MEETING NOTES
Waste Management Area A-AX:
Follow-Up Meeting on Data Quality Objectives Step 4, Define the Boundaries of the Study

MEETING DATE: September 16, 2020

Boundary of Consolidated Waste Site 200-E-131

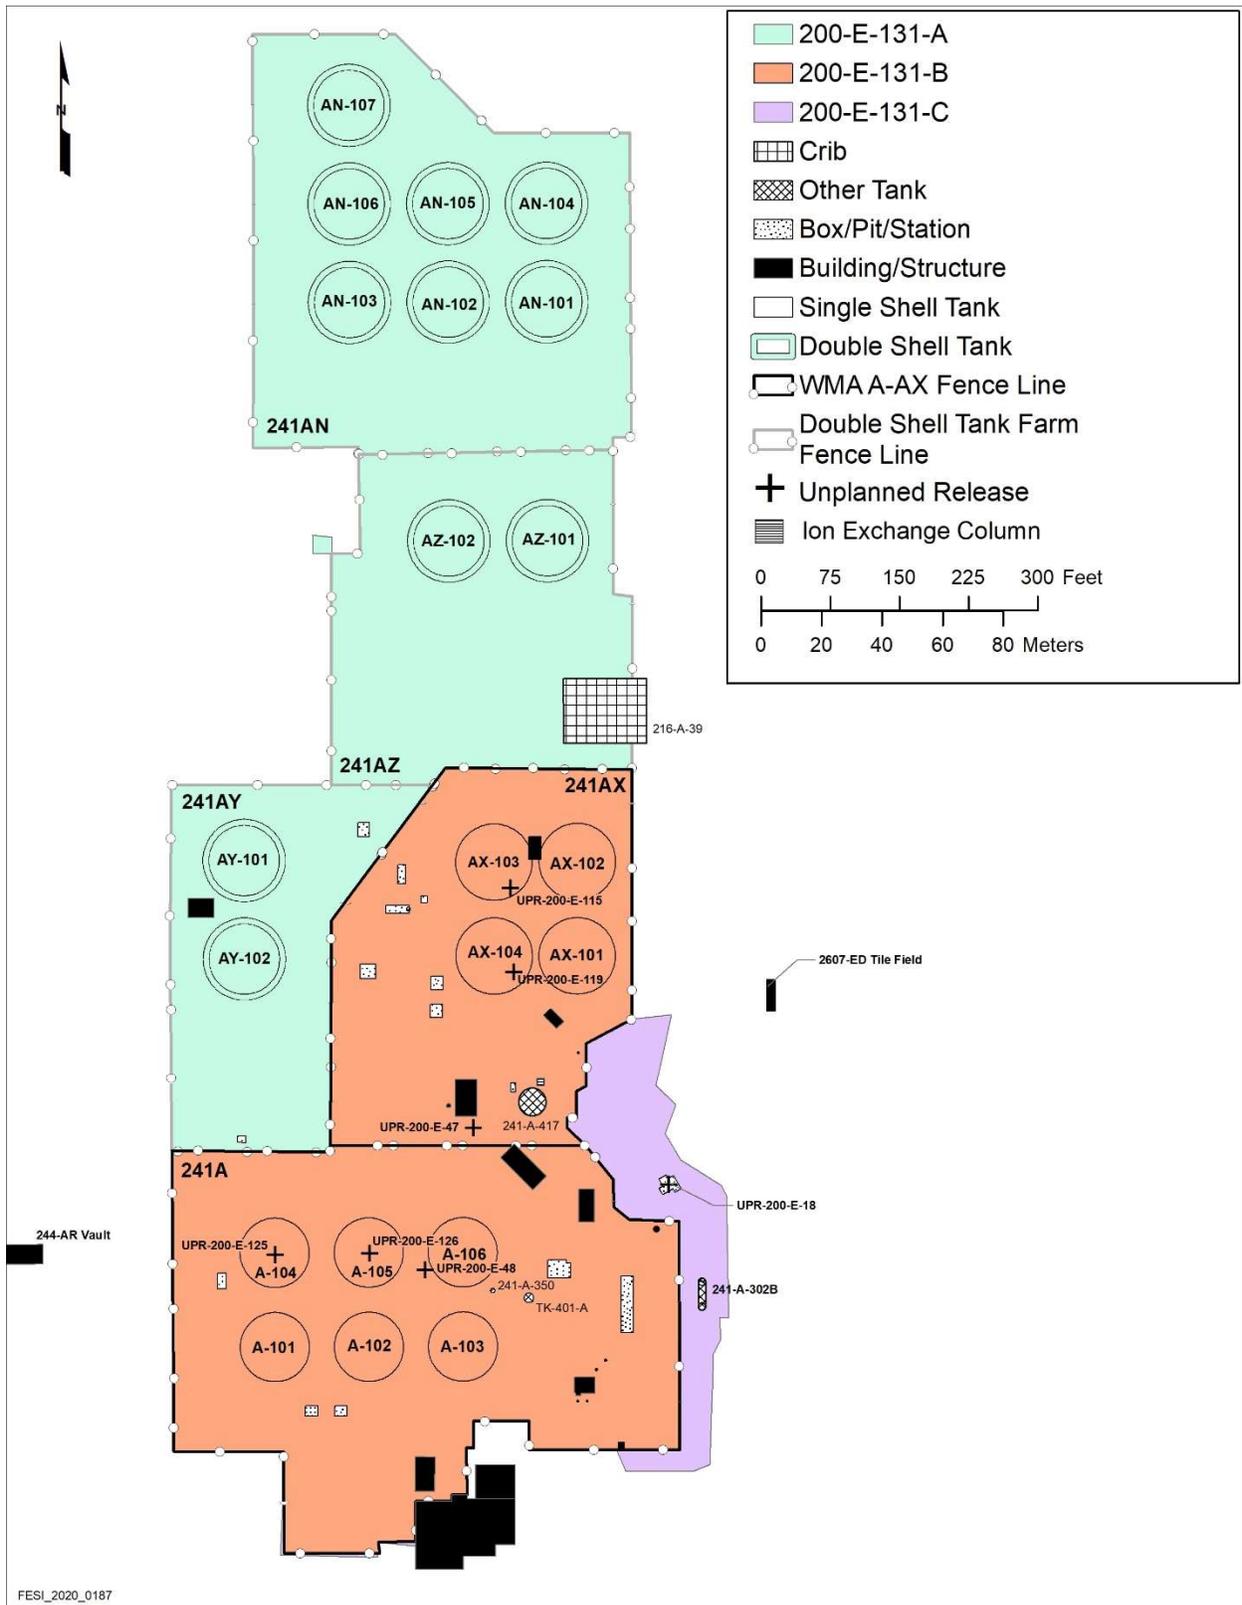
Ms. Menard then turned to DOE's September 1, 2020, proposal to segment the 200-E-131 waste site. Ms. Menard stated that Ecology had met internally and offered a counter proposal. Referring to Attachment 1, Ms. Menard suggested that the southern portion of the purple segment (containing the 241-A-302B Catch Tank and a steeper slope) be investigated as part of WMA A-AX, and the northern portion (containing several 200-IS-1 Operable Unit [OU] features and a less steep slope) be segregated and addressed through OU investigations. Jeff Lyon requested a caucus, and the Ecology participants left the meeting.

Upon Ecology's return to the meeting, Mr. Lyon stated that all the area under evaluation in the WMA A-AX Performance Assessment should be addressed by the WMA A-AX RFI, and that area should include all of the purple segment of 200-E-131 shown in Attachment 1. Additionally, Mr. Lyon stated that a portion of the green segment of 200-E-131 should also be included in the WMA A-AX investigation. He defined that as the portion surrounding the 241-AY-102 Tank (AY-102), extending in a rough rectangle from just south of the 241-AY-101 Tank southward to the northern edge of the orange segment of 200-E-131. He explained that AY-102 is unfit for use and must be closed, so characterization of the soil surrounding the tank should proceed now with WMA A-AX.

Julie Robertson provided a brief description of the 2607-ED waste site. The waste site is a sanitary septic system that includes a tank just inside the southeast fenceline of the 241-AX Tank Farm, and a tile field that is well to the east of the tank farm (shown in Attachment 1). Ms. Robertson said that there was no indication of unusual discharges to the system in the Hanford Site Waste Information Data System (WIDS) and that she had not performed a search to identify whether any characterization data might be available for the tile field. She noted that the system is not identified in the *Hanford Federal Facility*

Ms. Robertson proposed that the 2607-ED Septic Tank be addressed with WMA A-AX, since it is inside the 241-AX Tank Farm, and that the 2607-ED Tile Field be addressed by an OU. Ms. Menard agreed that it would be appropriate to address the tank with WMA A-AX and the tile field with an OU.

(AGREEMENT: As part of Step 4 of the WMA A-AX DQO process, the attendees agreed that the 2607-ED Septic Tank should be addressed with WMA A-AX, and the associated 2607-ED Tile Field should be addressed as part of operable unit investigations.)
